Service Bulletin

SB-10057079-2072

SUBJECT: Service Update for Inventory and Customer Vehicles
Rear Door Inside Handle Release Cable Misrouted
Expires with Base Warranty

MODELS: 2014-2015 Cadillac CTS Sedan (VIN A)

3997960

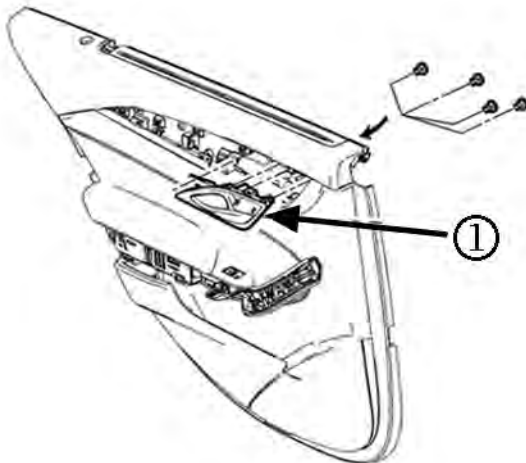
1. Remove the rear side door latch (1) and the rear side door inside handle cable (2) from the affected door. Refer to *Rear Side Door Inside Handle Cable Replacement* in SI.

4. Install a new rear side door latch (1) and new rear side door inside handle cable (2) to the affected door. Refer to *Rear Side Door Inside Handle Cable Replacement* in SI.
5. Prior to installing the door trim panel, verify proper operation of the door glass lowering fully into the door.

3997967

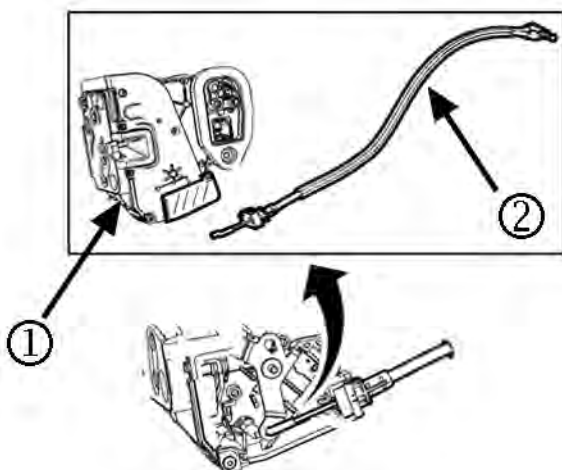
Note: When installing the new rear side door inside handle cable, ensure proper routing of the cable within the door. As shown in the graphic above, the cable **MUST** be routed on the inboard side (1) of the vertical glass channel, **NOT** the outboard side (2).
